**re: Geotechnical Review of Grading Plan & Site Servicing
Proposed Multi-Storey Building
384 Arlington Avenue – Ottawa, Ontario**
**to: Windmill Developments – Kristen Jorgensen –
Kristen.jorgensen@windmilldevelopments.com**
date: October 7, 2024
file: PG6263-MEMO.03

Grading Plan Review

Site Servicing Plan Review

FIGURE 1 - SITE SERVICING PLAN REVIEW

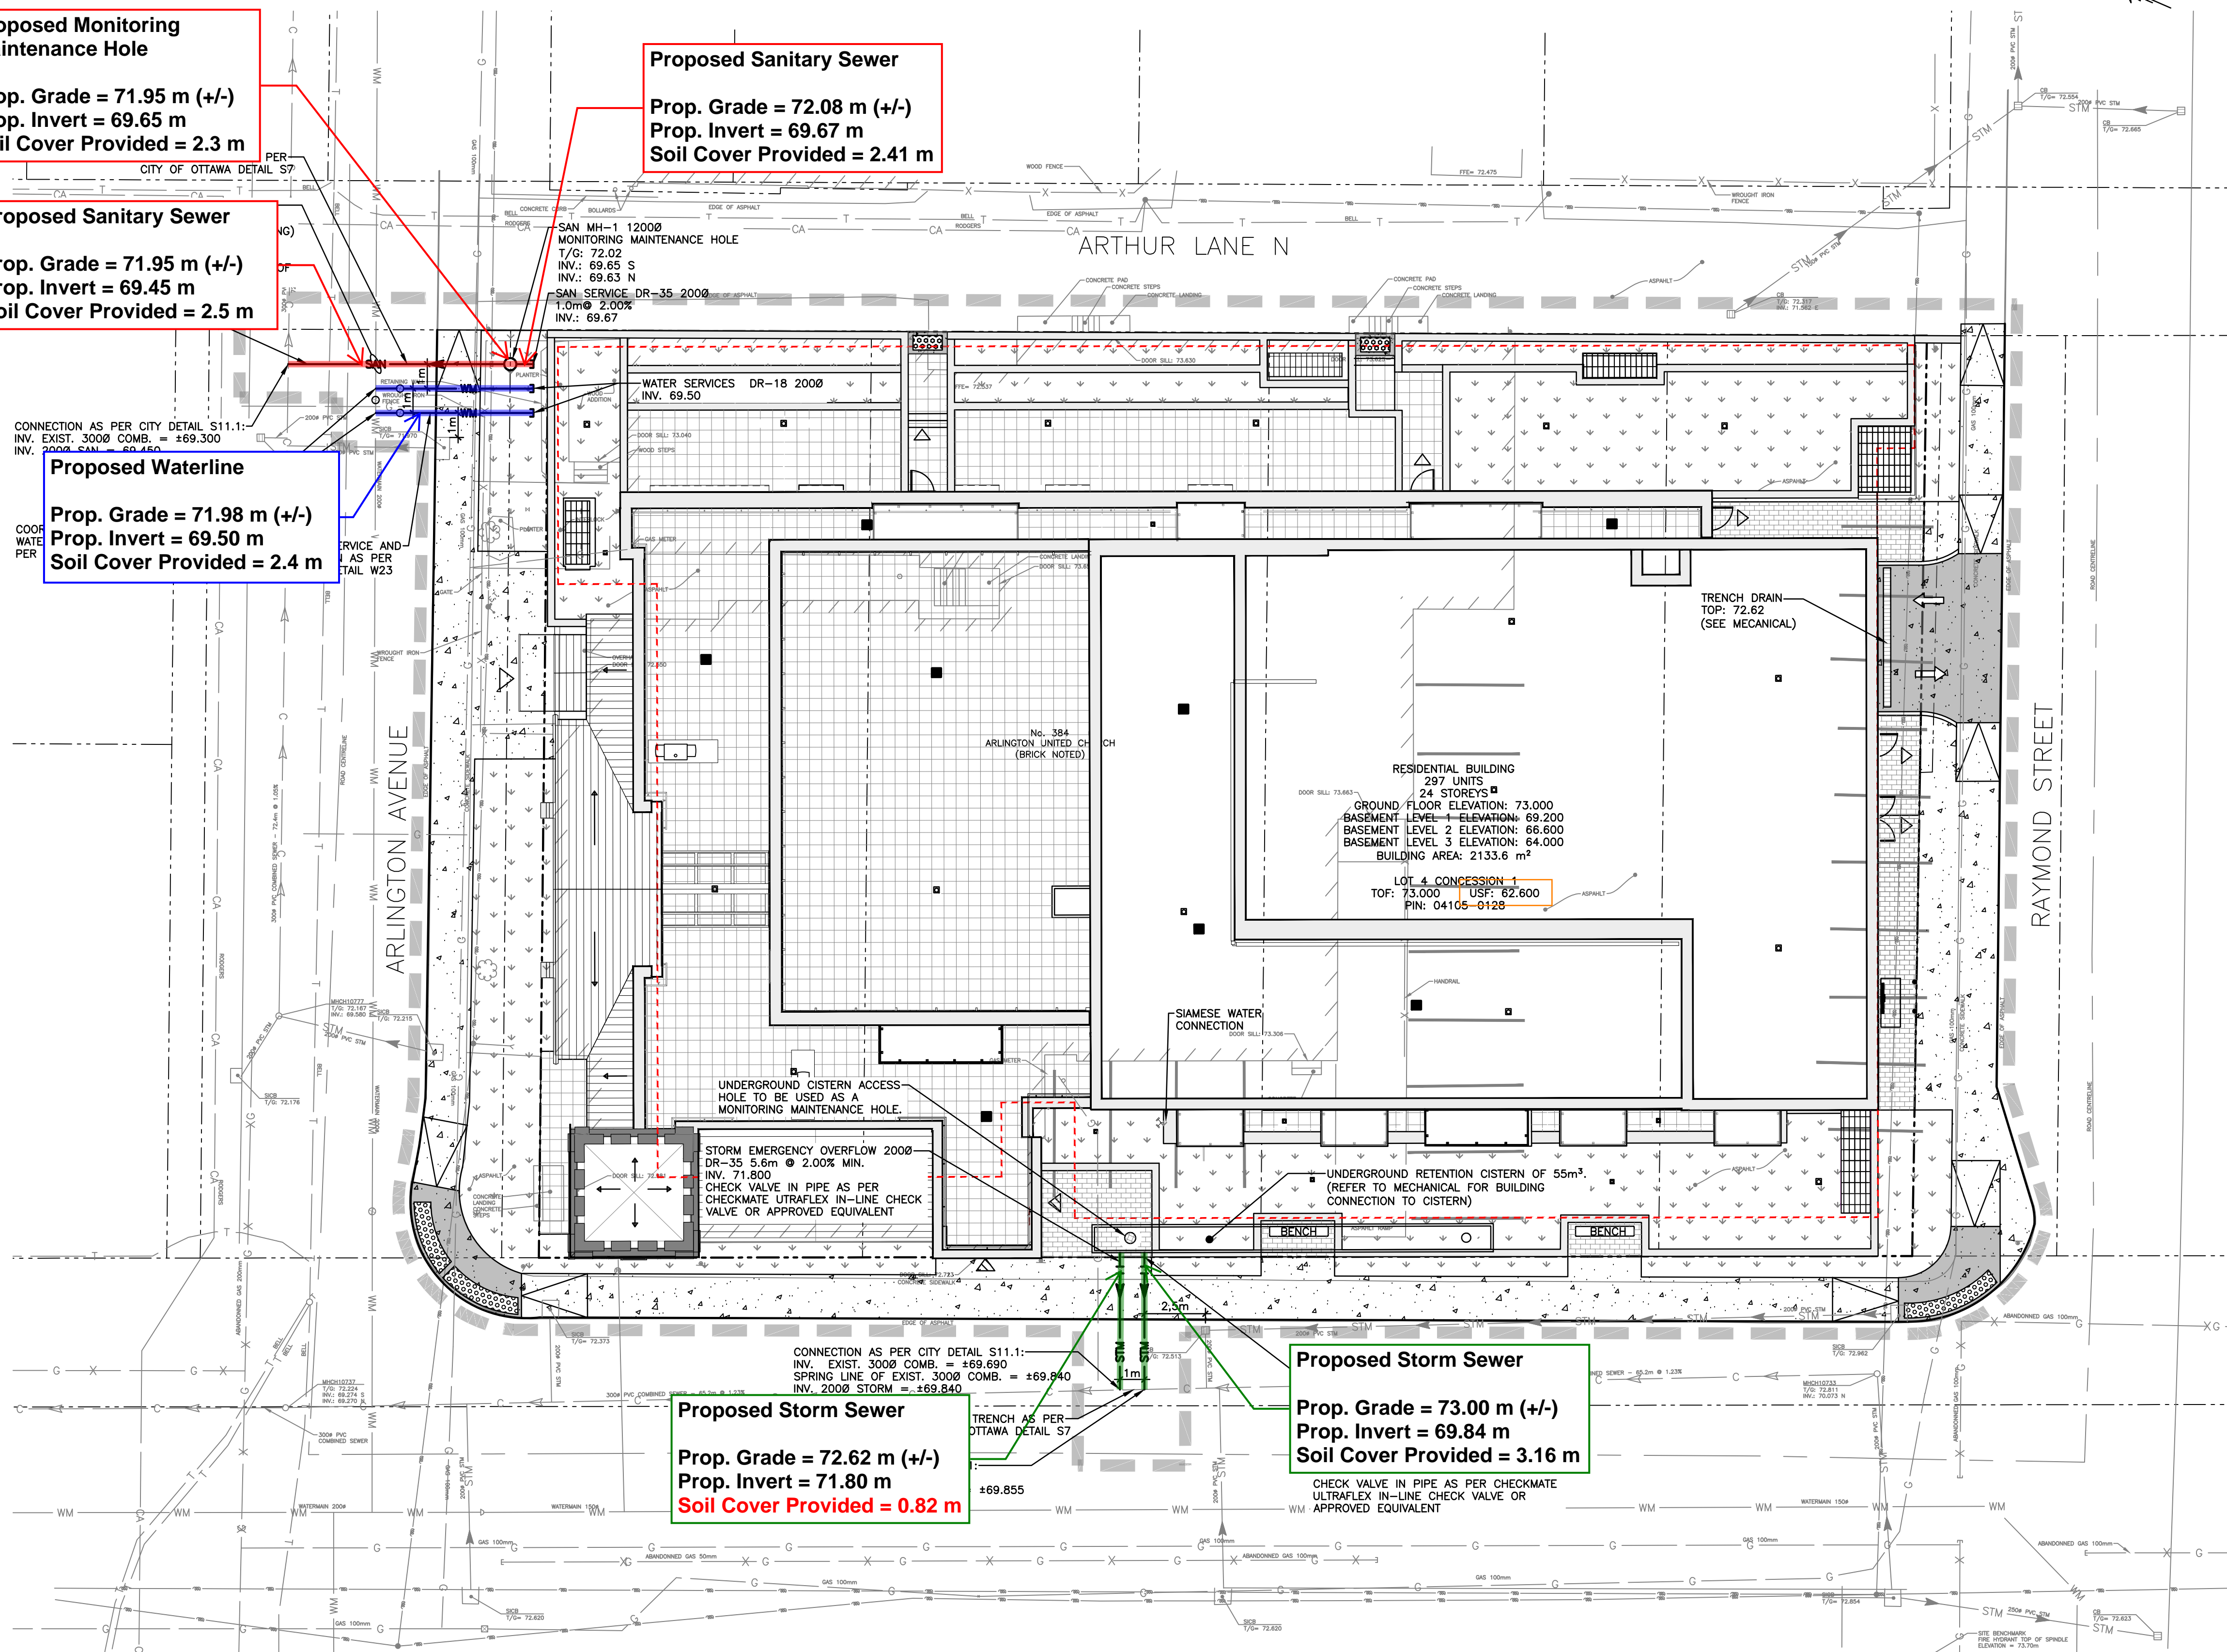
Based on our review of the site servicing plan, sufficient soil cover has been provided to the proposed watermain, sanitary services and the primary stormwater services. However, the emergency stormwater overflow services were noted to be provided with insufficient soil cover. Reference should be made to Figure 1 – Site Servicing Plan Review, attached.

Proposed Storm Sewer

Prop. Grade = 72.62 m (+/-)
Prop. Invert = 71.80 m
Soil Cover Provided = 0.82 m

Where insufficient soil cover (i.e. less than 2.1 m of soil cover is present above the obvert of the pipe) is available, the following frost protection criteria should be followed:

Table 1 – Rigid Insulation Recommendations for Storm Sewer Pipes with Reduced Soil Cover			
Thermal Condition	Soil Cover Provided (mm)	Insulation Dimensions	
		Thickness (mm)	Extension (mm)
Unheated	600 to 900	125	Extend 1200 mm horizontally beyond edge face of the pipe
	900 to 1200	100	Extend 1200 mm horizontally beyond edge face of the pipe
	1200 to 1500	75	Extend 900 mm horizontally beyond edge face of the pipe
	1500 to 1800	50	Extend 600 mm horizontally beyond edge face of the pipe
	1800 to <2100	25	Extend 300 mm horizontally beyond edge face of the pipe

All rigid insulation should consist of either Dow Chemical High-Load 40 (HI-40), Styro Rail SR.P400, or equivalent approved by Paterson. The placement of all insulation within the service trenches must be reviewed and approved by Paterson personnel at the time of construction
